Solano County

Agenda Submittal

File #: PC 23-021 Contact: Eric Wilberg/Kathy Pease

Title: Conduct a noticed public hearing to consider Rezoning Petition No. Z-22-04 and Use Permit

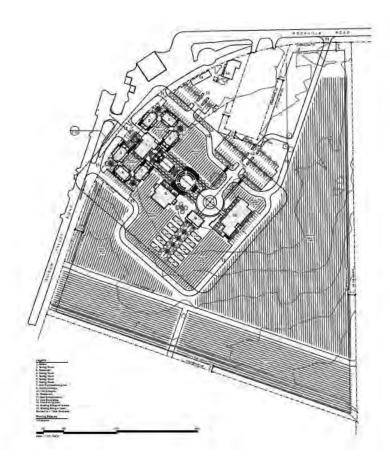
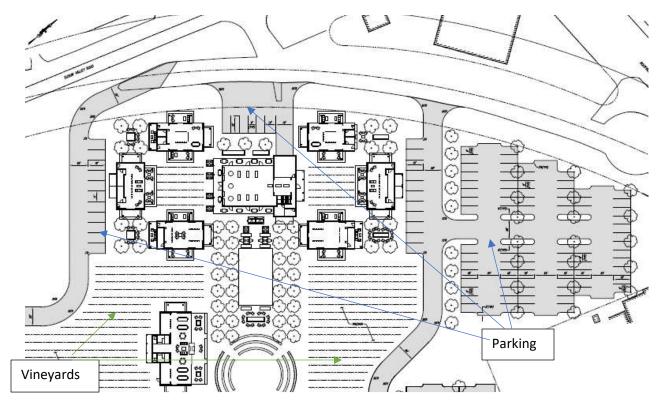
• Project Description fails to provide any visual renderings of individual project components. Further, Figure 3 (p. 10) does not include the project border along Rockville Road. Both deficiencies make it impossible for the public, or Commissioners, to assess aesthetic impacts. Instead, staff merely tell readers that a future Design Review process will prevent all problems (p. 19).

Response OG2: Figure 3 in the MND shows the site improvements. Figure 2 included in the MND shows the site relative to Rockville Road. Enough information is included in the MND to analyze impacts. For information, the following two figures show the site layout relative to Rockville Road. This information does not change the environmental analysis.
